126308
GeoEngineers

August 14, 1996

Revised Geotechnical Response
to County Checklist
Proposed Northwestern Short Plat of the
Rancho Del Oro Development
Skamania County, Washington
File No. 5274-001-36

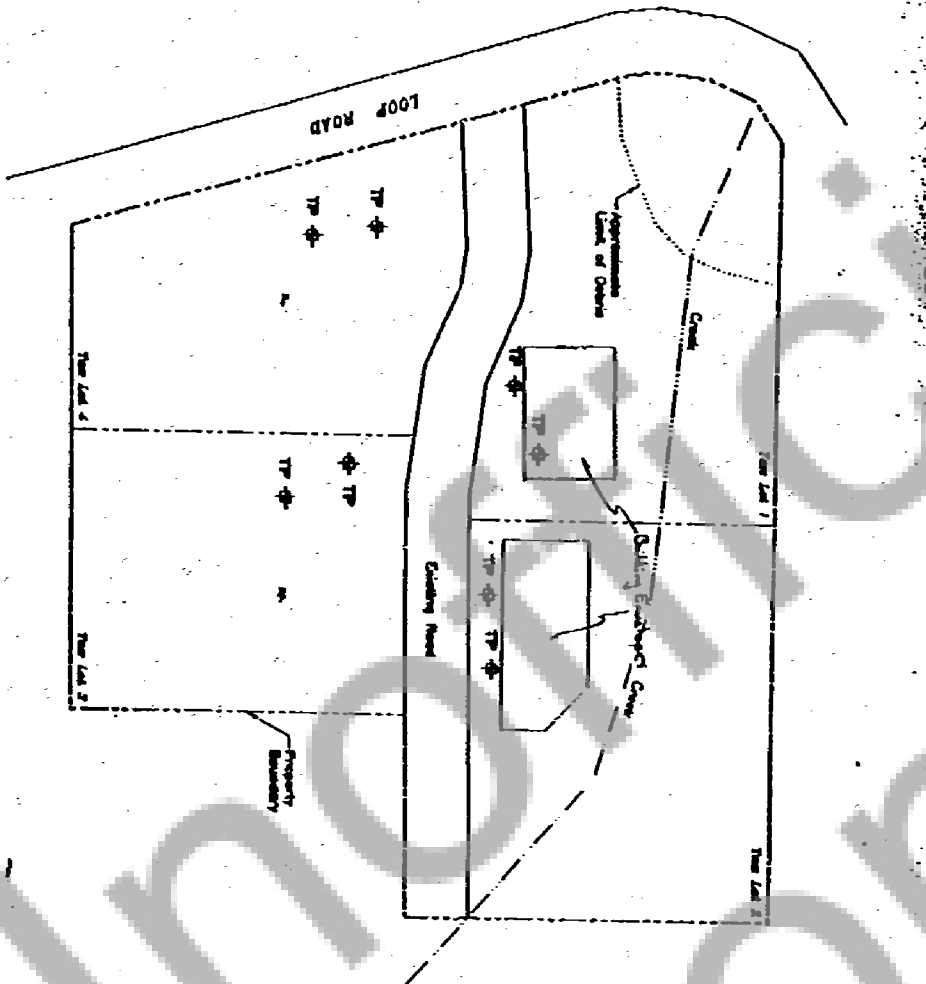
1. *Based upon this approval criterion, the applicant shall provide to the Planning Department a letter stamped and signed by an Engineer licensed to practice in Washington, that states that the slide across Loop Road does not pose a hazard to persons or property located within or near the short plat or explains how protective improvements can be constructed that will eliminate any potential hazards.*

2. Furthermore, most of the Engineering reports addressing this slide area indicate the water was a factor in the cause of the slide. The applicant's Engineer shall state that the lot sizes and building density of this Short Plat will not cause or increase the potential for additional slides in this area.

During the landslide, a debris flow breached Loop Road and deposited soil and vegetation across the northwest corner of Lot 1 of the proposed development, as depicted in the attached figure. Additional material flowed down the creek channel for several hundred feet into Lot 2. Based on our conversation with Mr. Gaynor, the deposits we observed are about 3 feet thick in the northwest portion of Lot 1. The deposits appeared to be less than about 2 feet thick in the stream channel. Our observations of the topography of the area and open excavations on site for percolation testing indicate that much of the site consists of old landslide materials, and that the current slide is likely a reactivation of a portion of a more extensive slide and mudflow deposit area.

We understand that plans call for developing a Lot 1 homesite in the building envelope shown in the attached figure. We recommend that the residence in this building envelope be located on the knoll (likely an ancient inactive landslide block). This knoll extends approximately 10 feet above the surrounding grades, and we understand that it would be graded down about 4 feet to allow for a level homesite. Based on this home site location and elevation on Lot 1, it is our opinion that further debris flows directly from the upslope slide area or stream channel will not pose a hazard to the residence or its occupants. On Lot 2, we recommend that the homesite be located as far south and away from the stream channel as possible as depicted by the recommended building envelope for Lot 2 on the attached figure. We also recommend that the residence on Lot 2 be raised a minimum of three feet above surrounding grades with structural fill (suitable soils compacted to 92% dry density relative to ASTM D-1557). Based on our observations, it appears that the current slide and associated debris flows do not pose a hazard to Lots 3 and 4. Furthermore, although water was likely a primary cause of the Loop Road

landslide, it is our opinion that the lot sizes and building density of this Short Plat will not cause or increase the potential for additional slides in this area.
